Subject: Supplemental Data Response, Set 3
Hidden Hills Solar Electric Generating System (11-AFC-2)

Hidden Hills
Solar Electric Generating System
(11-AFC-2)

**Supplemental Data Response, Set 3
(Responses to Project Description, Biology,
Socioeconomics, and Traffic and Transportation)**

FIGURE PD2-1
Site Plan and Linear Corridors
 Hidden Hills Solar Electric Generating System

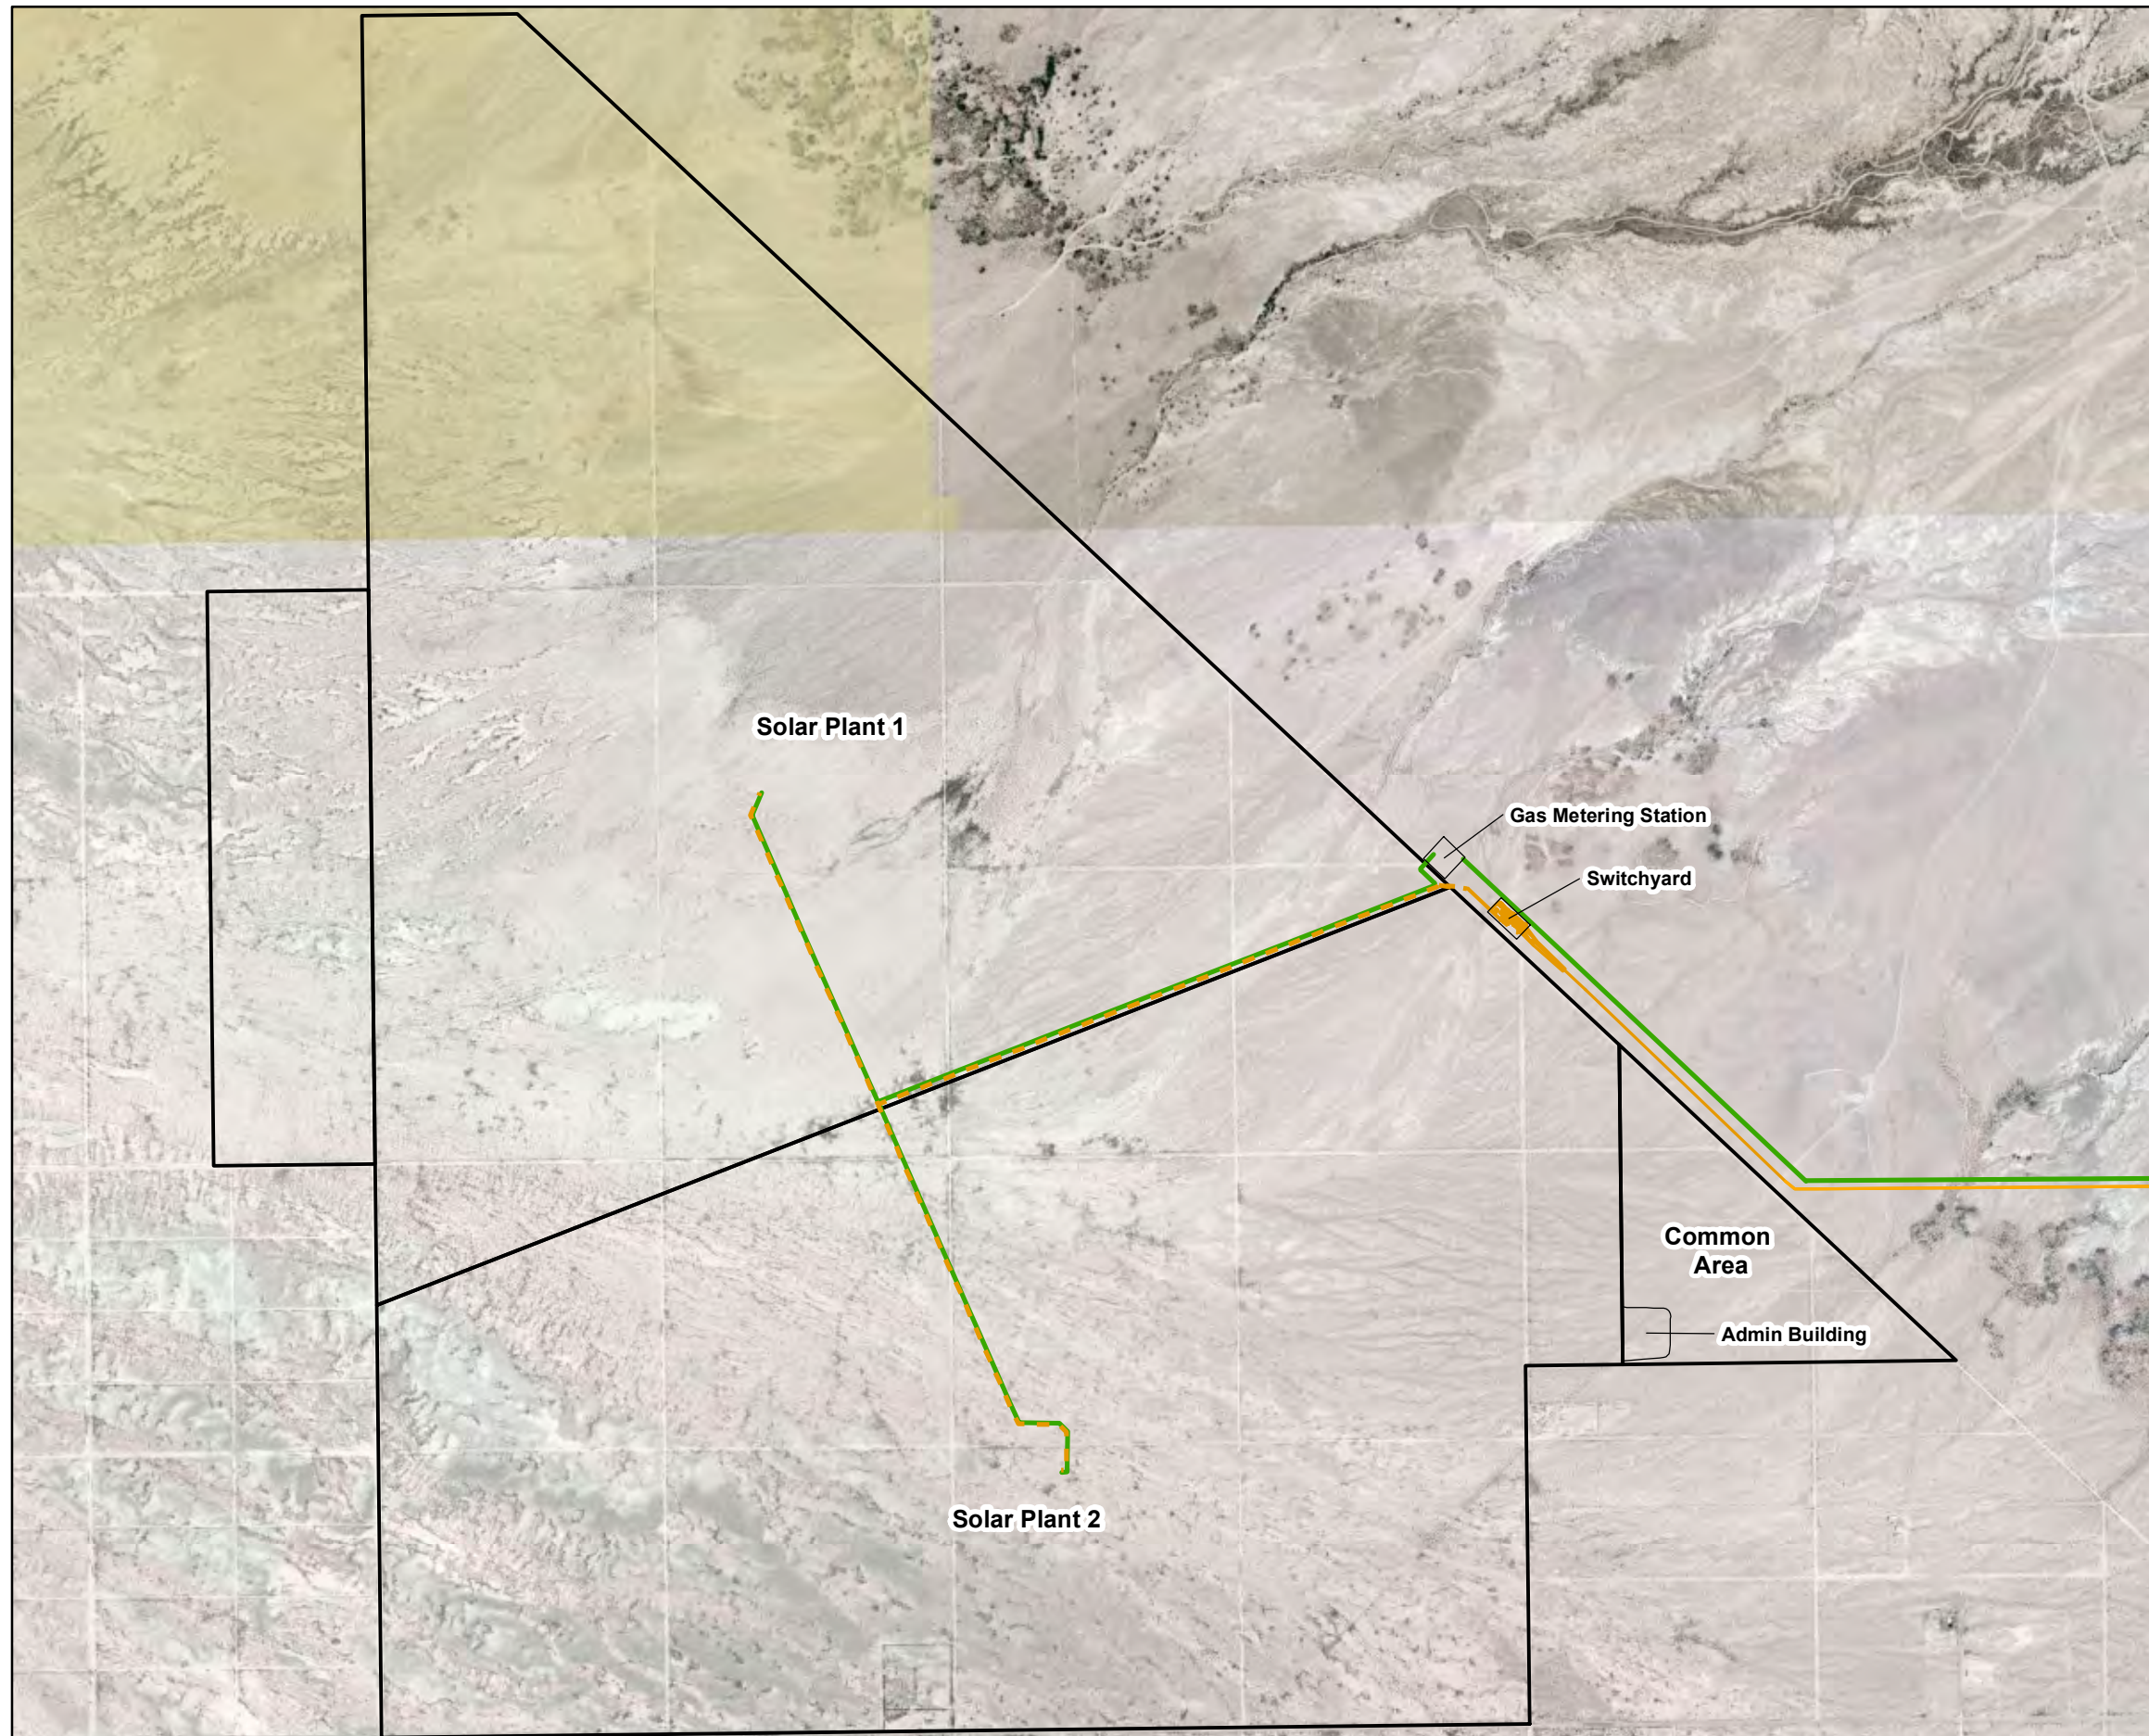
PD-2 Would CH2 put together a figure that shows the switchyard location and gas line/t-line routes?

Response: Figure PD2-1 presents the approximate location of the switchyard and gas metering station in Nevada and shows the linear corridors onsite.

Figure TT1-1
Access Roads and Paved Internal
Roadways
Hidden Hills Solar Electric Generating System

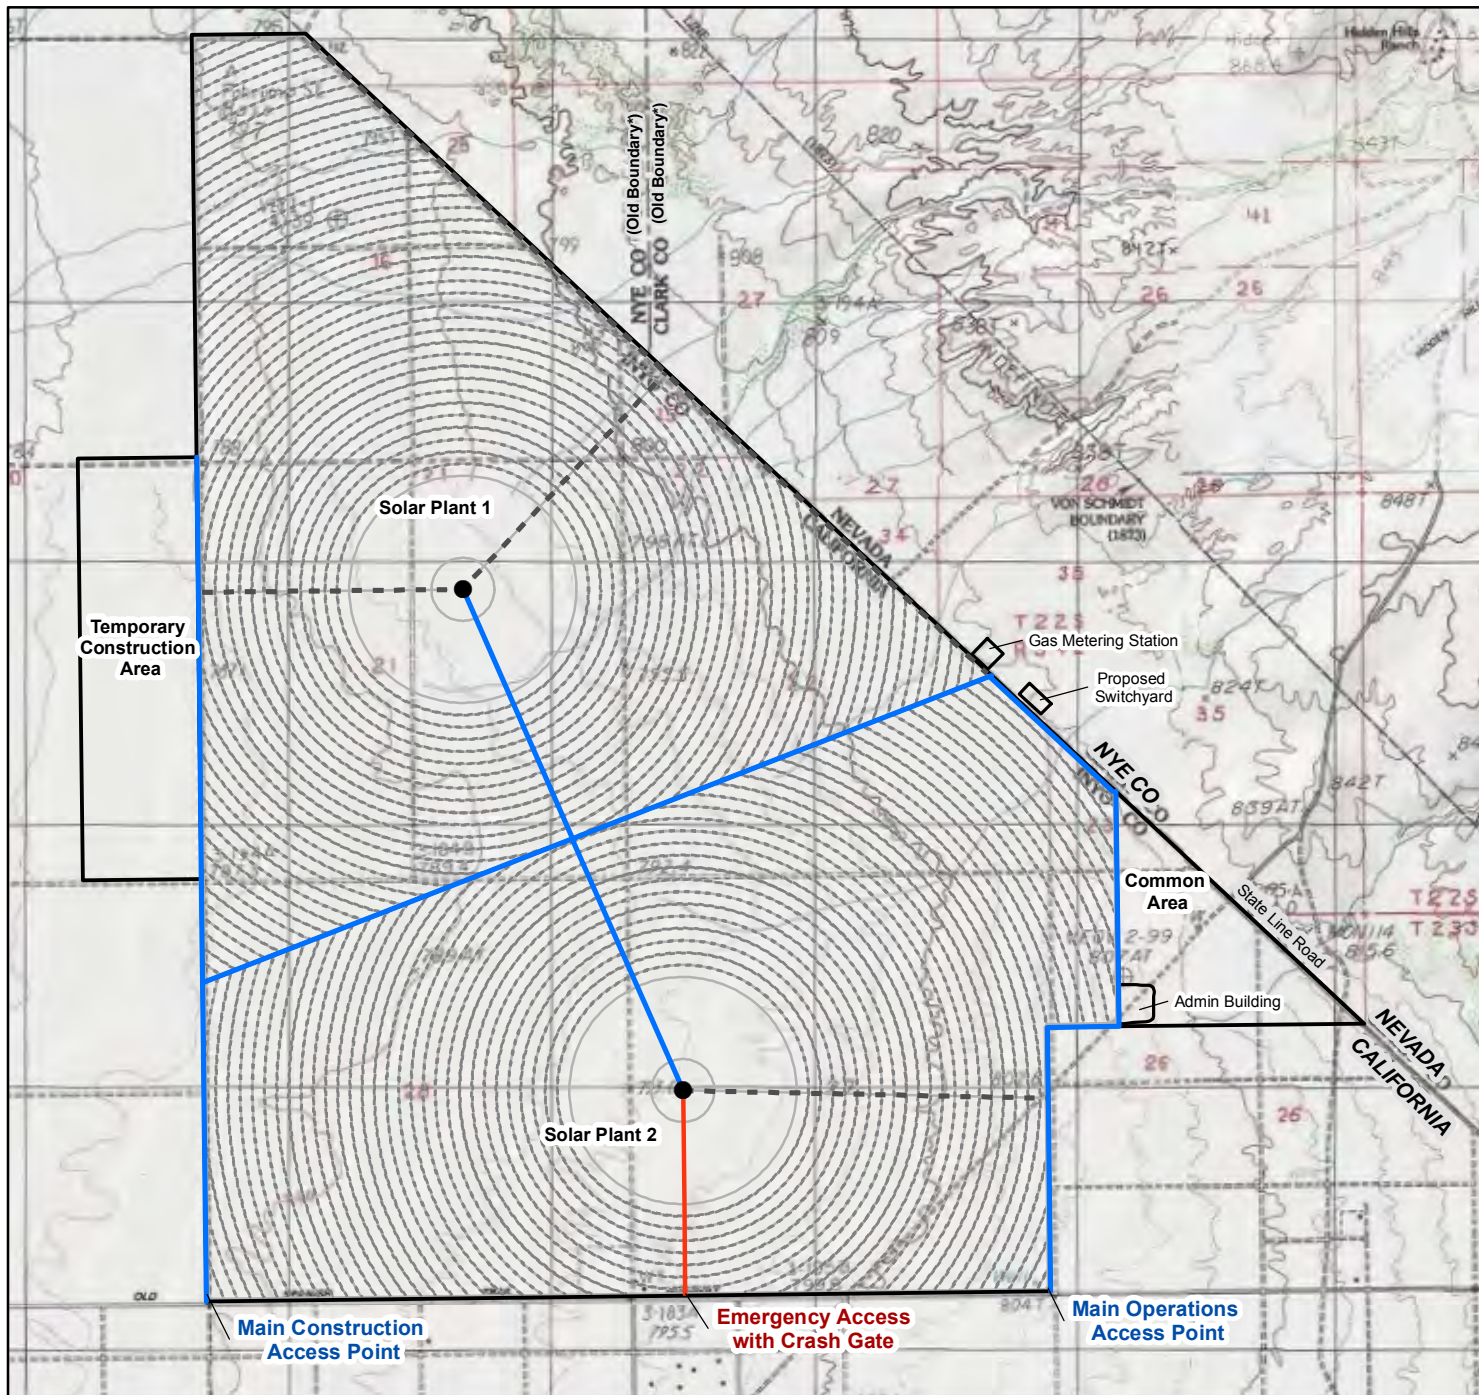
TT-1. The AFC states: Primary access to the project site would be from Tecopa Road to the project entrance road on the east side of the project. Secondary access would be from Tecopa Road along the west side of HHSEGS, then along the paved road between the two solar plants. Could you please provide a map depicting this primary route? Or provide an updated Figure 1.2-3 - Site Plan and Linear Facilities if that would be more efficient.

TT-2. Clarification: Would the construction traffic/trucks utilize the same primary access as discussed above or would there be a new access point to the 180 acre laydown area? If so, please indicate on the new map/updated figure.

Response: Figure TT1-1 shows the primary access roads from Tecopa Road to the project site. During construction, primary access to the solar fields and the temporary laydown area will be along the western side of the project site. During operation (and during portions of construction on the eastern part of the site, for example, in the common area) primary access to the site will use a paved road on the eastern side of the site.

Response: Access to the construction laydown area is shown on Figure TT1-1.
